**NOTICE OF DECISION**  
**Family Pet Clinic Addition and Site Modifications – 131 and 151 N Elliott Way**  
**Design Review – DR222-0006**

**Family Pet Clinic Addition and Site Modifications – 131 and 151 N Elliott Road  
Design Review – DR222-0006**

FILE NO: DR222-0006

REQUEST: Addition with site modifications

## Proposed Site Plan

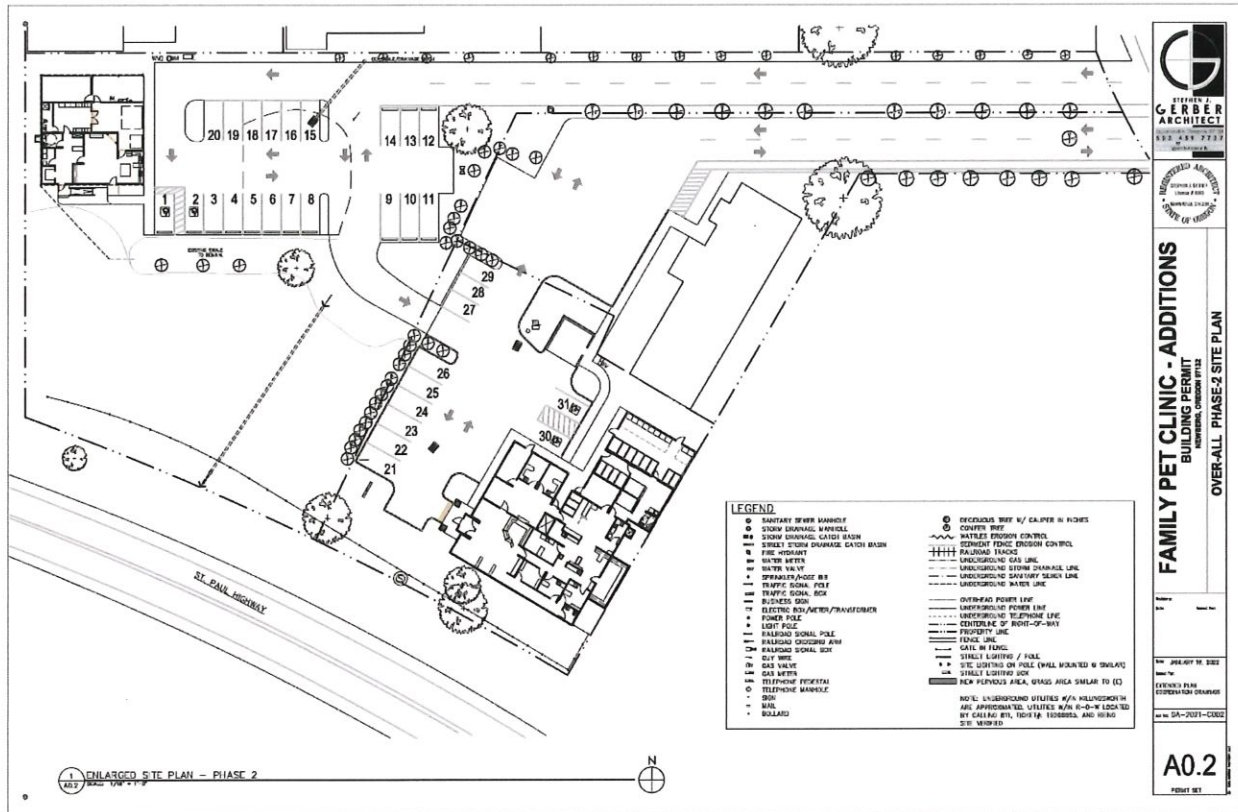
The service drive between 131 and 151 N Elliott Road has a paved width of 14 feet 5 inches at its minimum with a recorded 12-foot-wide easement. Therefore, it would be a one-way service and will need to be marked as such. Per DR2-13-007, it was conditioned that this service drive be marked as one-way. An updated site plan showing the access road between 131 and 151 N Elliott Road marked as a one-one way service drive will need to be submitted during building permit application and approved prior to issuance.

An updated site plan showing the access road between 131 and 151 N Elliott Road as a one-one way service drive will need to be submitted during building permit application and approved prior to issuance.

**Finding:** Six existing parking spaces at 151 N Elliott Road will have a reduced width of approximately 8 feet and 8 inches. Due to the fact the proposed parking configuration is not meeting NMC 15.420.010(B)(3)(h) and concerns regarding one of the ADA parking spaces location to the refuse storage, staff is unable to determine if the proposed number of compact spaces is within the 30 percent. An updated site plan showing the proposed parking lot configuration meeting the requirements in NMC 15.420.010 (B)(3)(h) will need to be submitted

**Finding:** Noted on the applicant’s site plan is an 8-foot by 30-foot loading zone. Per NMC 15.440.080 an off-street loading berth shall be 10 feet by 35 feet. Therefore, this area is not meeting the required size. However, if this area will be used as a drop off and pick up space for animals, the area should not be marked as a standard “loading zone” that would be identified to meet the size standards listed in this code. If a standard loading zone is desired, an updated site plan showing the loading zone meeting NMC 15.440.080 will need to be submitted with the building permit and approved prior to issuance.
